# RESPONSE TO SUBMISSIONS

LANG WALKER AO MEDICAL RESEARCH BUILDING – MACARTHUR

SSD-17491477

Figure 1b; Service access swept path

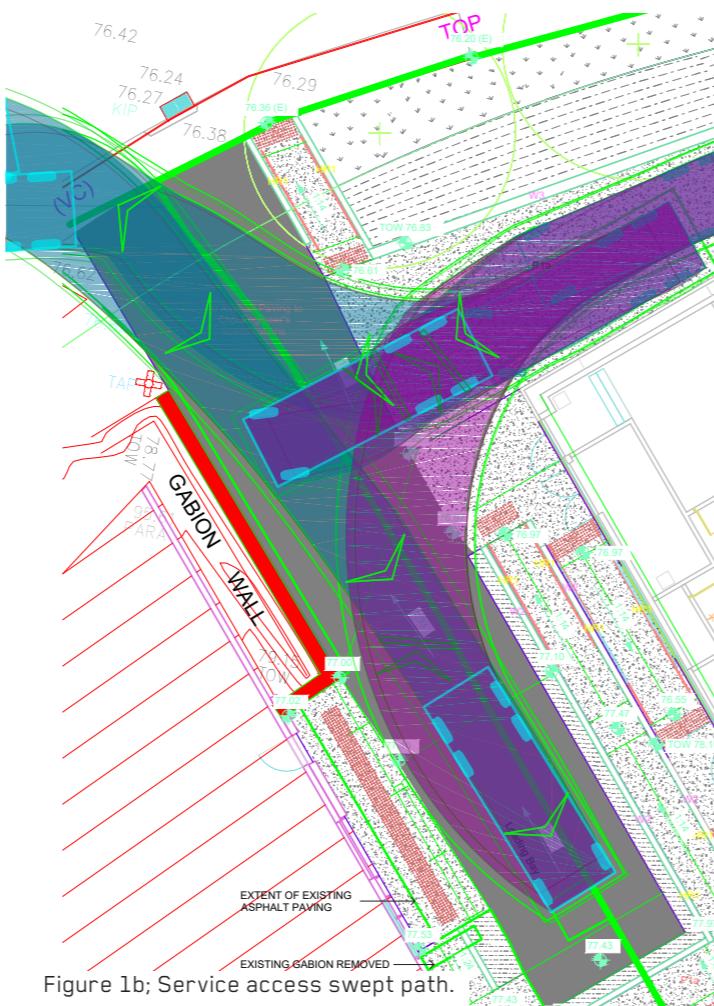
Council is of the view that the proposed loading area facing Parkside Crescent would not be the best location for loading from an aesthetic perspective. Council would appreciate if the loading area could be relocated so that it would not be visible from Parkside Crescent. The opportunity for the loading bay to be accessed from within the hospital site should be pursued, as this is a "back-of-house" activity that should not be located between the building and the street.

From a traffic management perspective, additional driveway access from Parkside Crescent should be avoided, as this would result in reduced on-street car parking, and would negatively impact on the safety of all road users. As stated above, the opportunity for the loading bay to be accessed from within the hospital site should be pursued.

The location of the loading bay has been adjusted to sit in the area indicated in Figure 1a. The hardstand area previously indicated as the loading bay must remain in order to facilitate the turning circle of waste management vehicles shown in the swept path on Figure 1b. The through site link has been retained through the use of ramps and walkways.

Refer to Figure 1b for proposed loading access to the LWMRB, updated to incorporate 'right in only' access and 'left out only' egress. In this scenario existing on-street parking is not impacted.

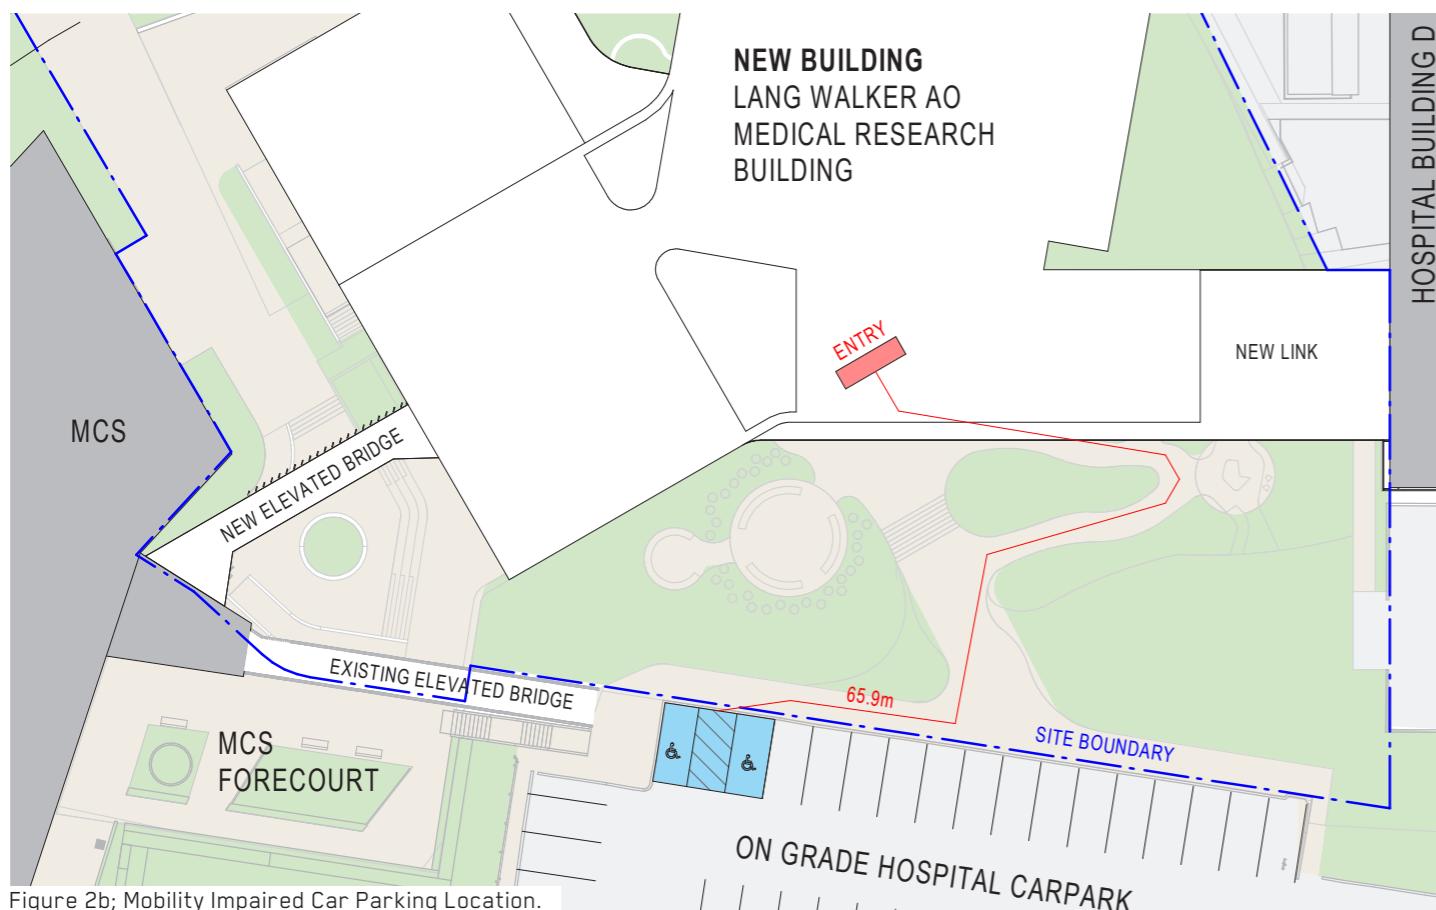
Details are to be provided of the access arrangements, drop-off zone(s) and estimated frequency of university shuttle bus services.	<p>Allocation of the Drop-off Bay will mean the removal of 1 (one) existing on street parking space. Refer Figure 3. Shuttle Bus Operating hours and Frequency (Autumn/Spring Semester, 2022):</p> <p>Operating Hours: 0700-2230 weekdays Frequency: Approximately 30mins</p> <p><a href="https://www.westernsydney.edu.au/campus_safety_and_security/security/accessibility_transport_parking/shuttle_bus_timetable">https://www.westernsydney.edu.au/campus_safety_and_security/security/accessibility_transport_parking/shuttle_bus_timetable</a></p>

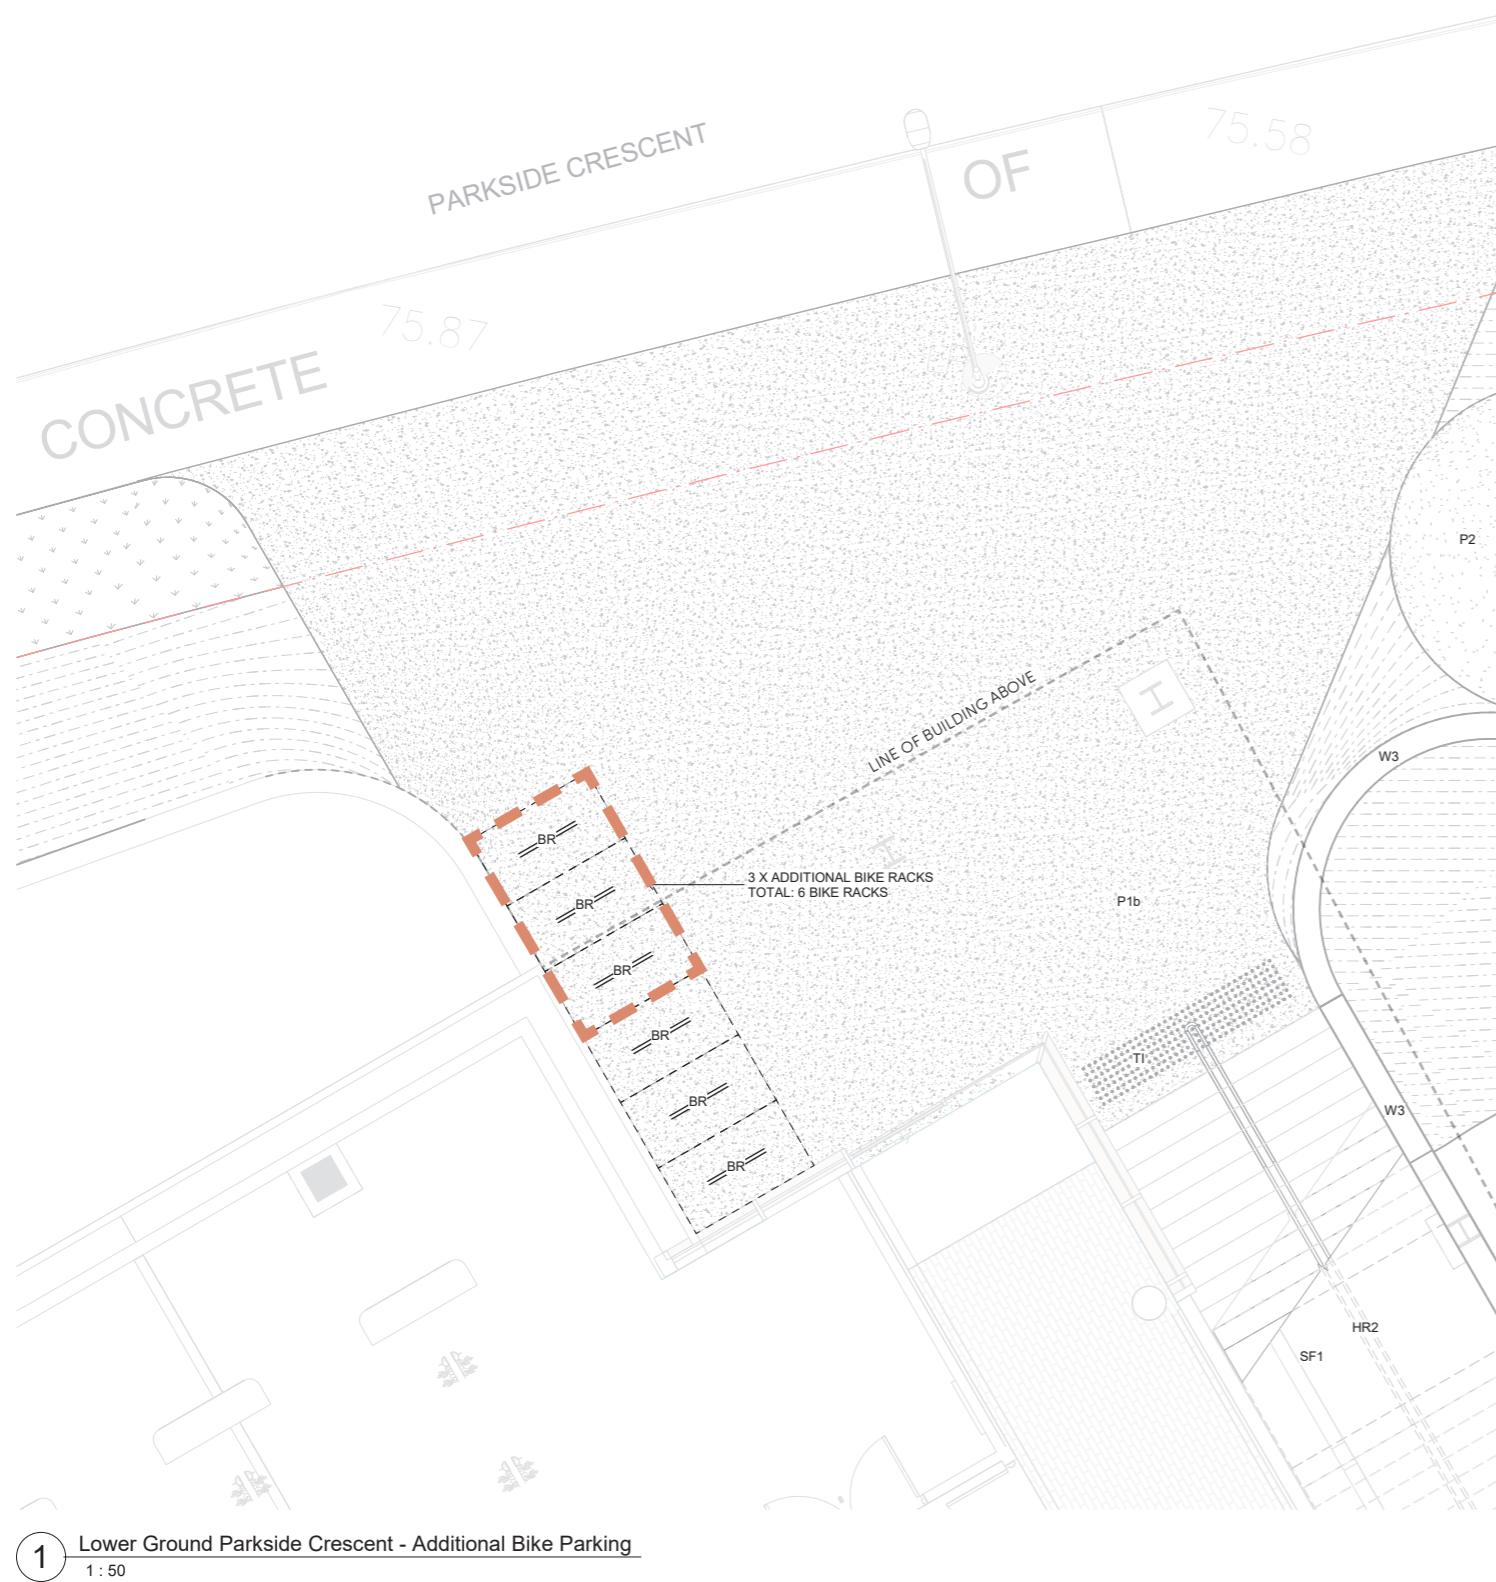
RURAL FIRE SERVICE (RFS)	RESPONSE
E. Landscaping within the required asset protection zone must comply with Appendix 4 of Planning for Bush Fire Protection 2019. In this regard, the following principles are to be incorporated:	-
A minimum 1 metre wide area (or to the property boundary where the setbacks are less than 1 metre), suitable for pedestrian traffic, must be provided around the immediate curtilage of the building;	A 600mm setback had been agreed on the 14/10/21 by Blackash Bushfire Consultants. Increasing the setback will impact on planting quantities and overall planting design.  The site is greater than 67m from adjoining bushfire prone land and is a low bushfire risk. There are no requirements within RFS documents that stipulate a 1m wide area and therefore the 600m provides access for pedestrians and fire fighters.
Planting is limited in the immediate vicinity of the building;	A 600mm gravel setback ensures planting isn't located in the immediate vicinity of the building.

Planting does not provide a continuous canopy to the building (i.e. trees or shrubs are isolated or located in small clusters);	Trees & shrubs have been strategically placed to avoid large clusters of continuous canopies.
Landscape species are chosen to ensure tree canopy cover is less than 15% (IPA), and less than 30% (OPA) at maturity and trees to not touch overhang buildings;	Trees and planting has been provided to meet IPA requirements. Ongoing management will ensure IPA is maintained to the life of the development.
Avoid species with rough fibrous bark, or which retail/shed bark in long strips or retain dead material in their canopies;	Acacia Binervia and Banksia Ericifolia have been removed from the landscape documentation and replaced with suitable species not containing rough fibrous bark.
Use smooth bark species of tree species which generally do not carry a fire up the bark into the crown;	There is a selection of smooth barked tree species which have been used in our planting design ie. Angophora costata, & Corymbia maculata.

Avoid planting of deciduous species that may increase fuel at surface/ground level (i.e. leaf litter);	All tree species selected are evergreen.
Avoid climbing species to walls and pergolas;	Climbing species have been used only on the small retaining wall located approx. 2.5m away from the building.
Locate combustible materials such as woodchips/mulch flammable fuel stores away from the building;	A 600mm gravel setback ensures combustible materials aren't located in the immediate vicinity of the building.
Locate combustible structures such as garden shed, pergolas and materials such as timber garden furniture away from the building; and	Any combustible materials are no less than 600mm from the building.
Low flammability vegetation species are used.	Vegetation species selected are suitable.

SUMMER SOLSTICE SOLAR STUDY, 12:00PM

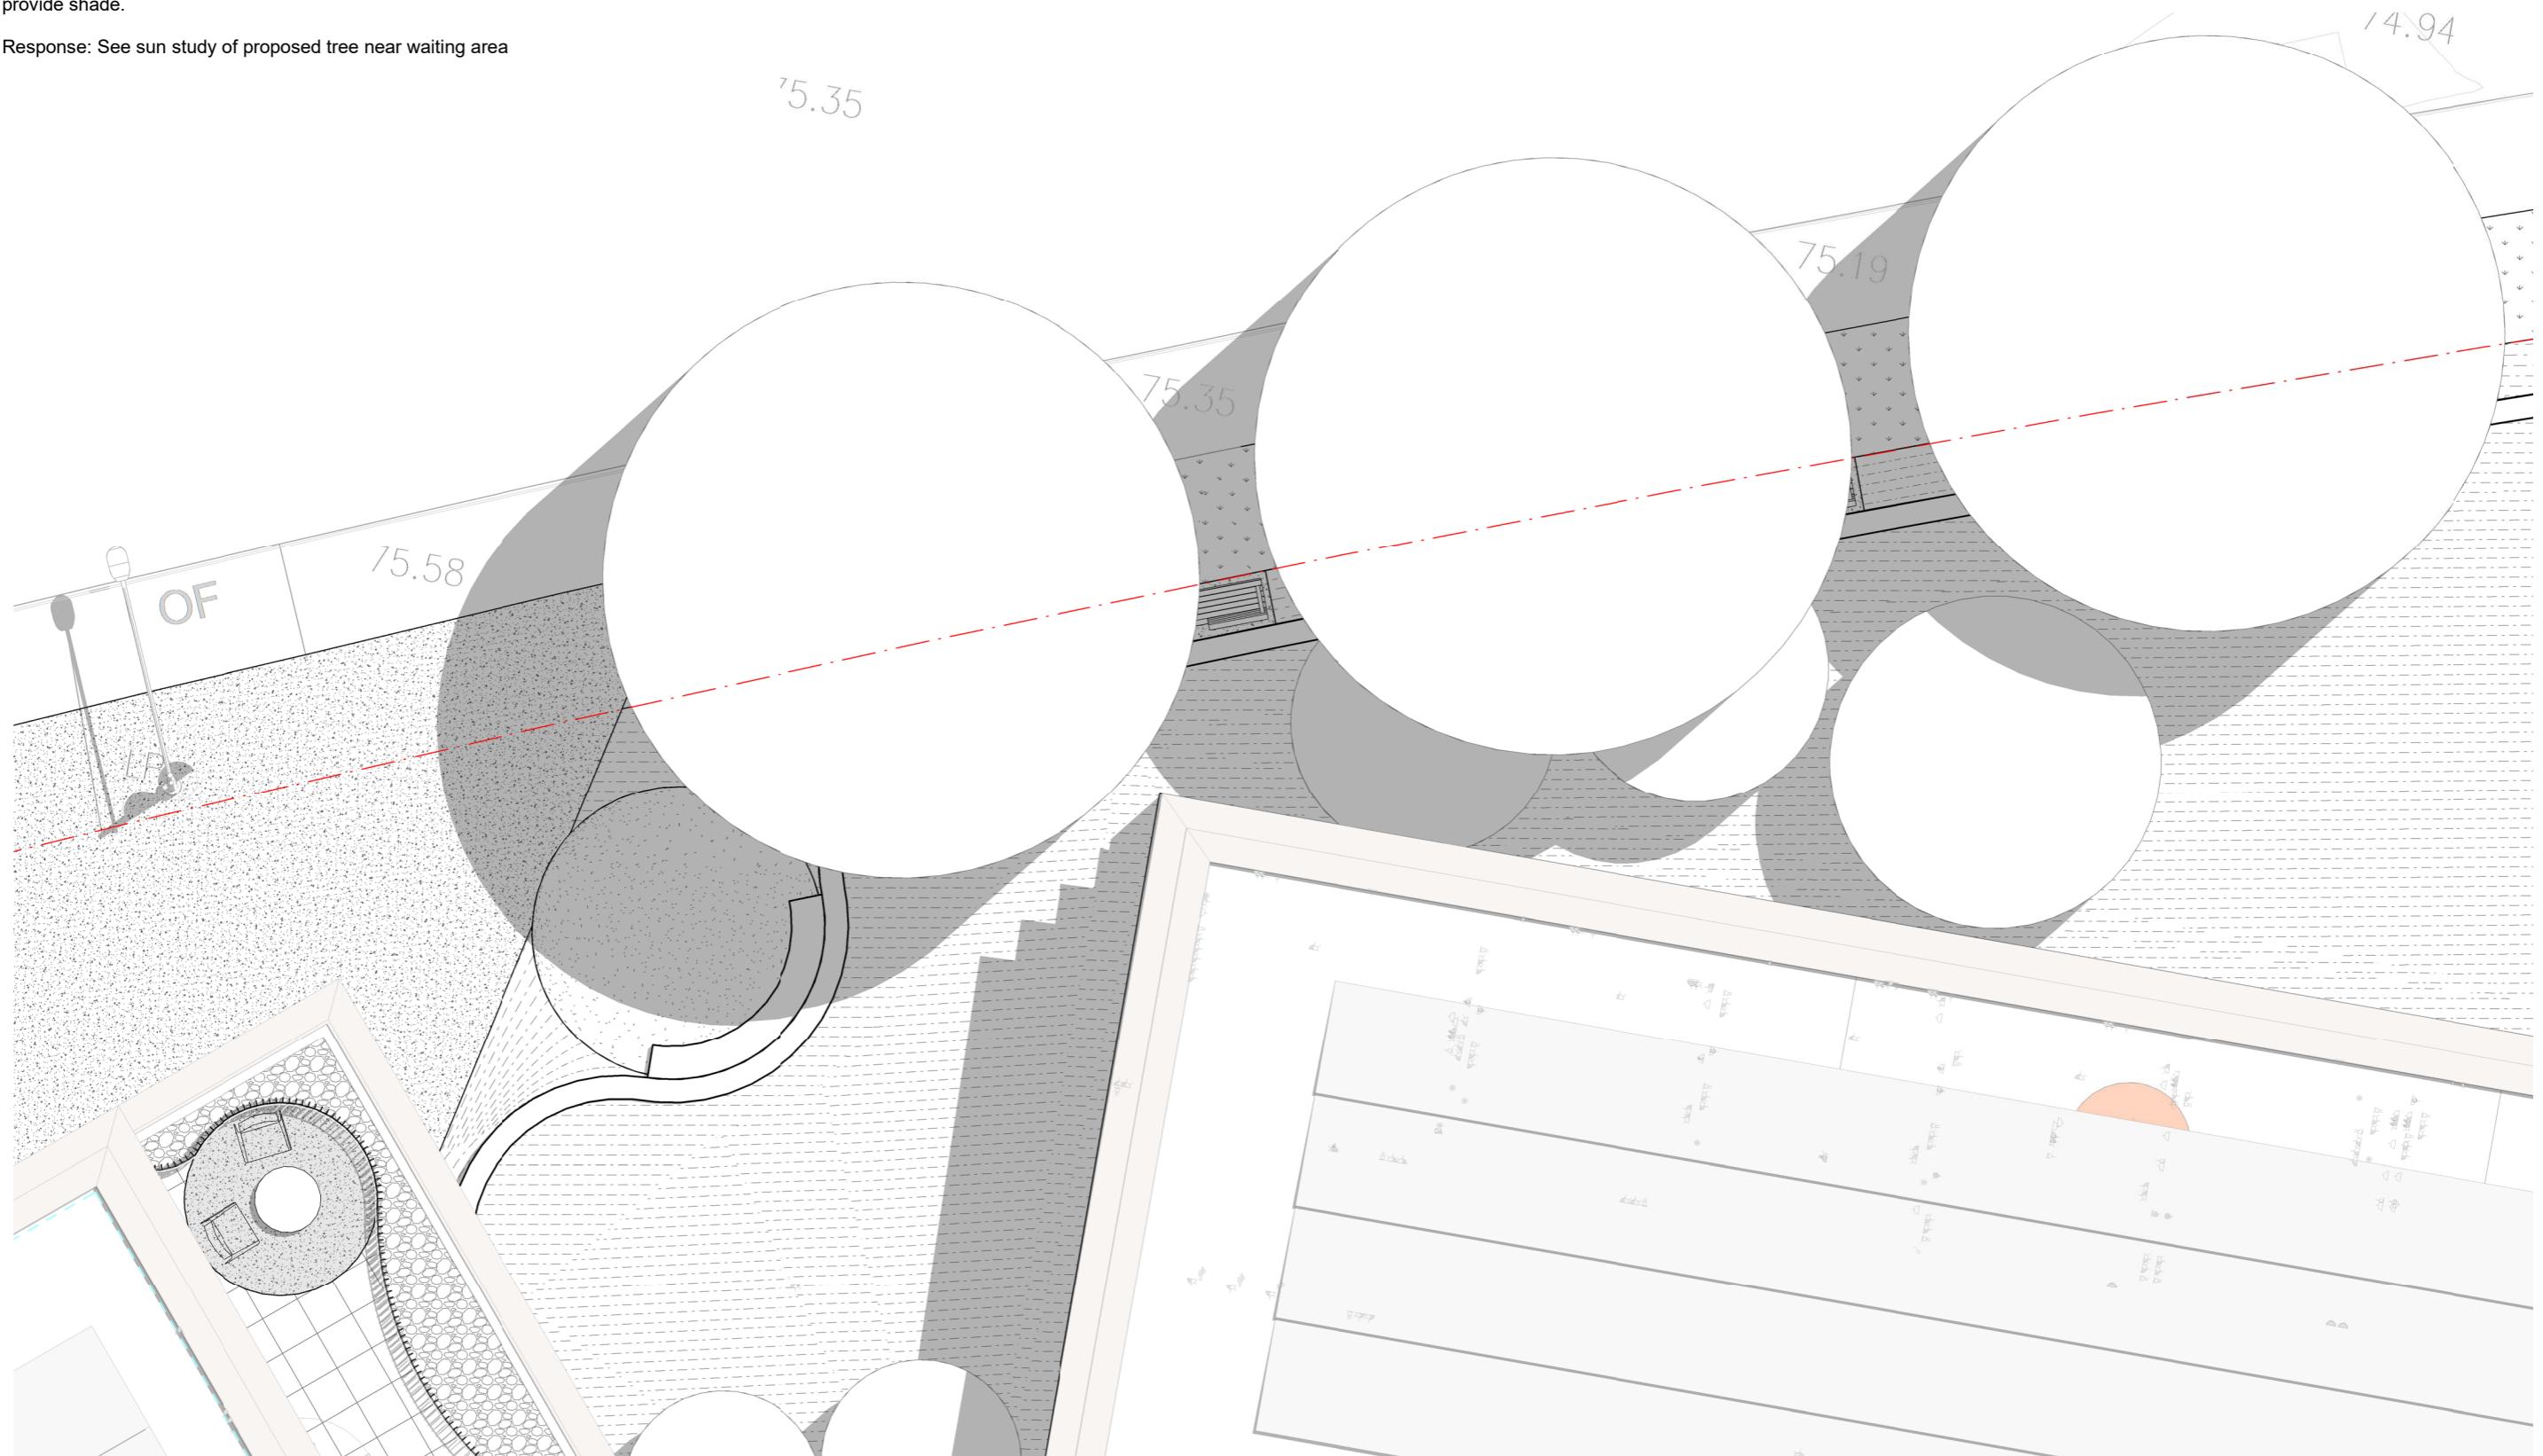
C. Locate a tree near the Parkside Crescent waiting area to provide shade.

Response: See sun study of proposed tree near waiting area
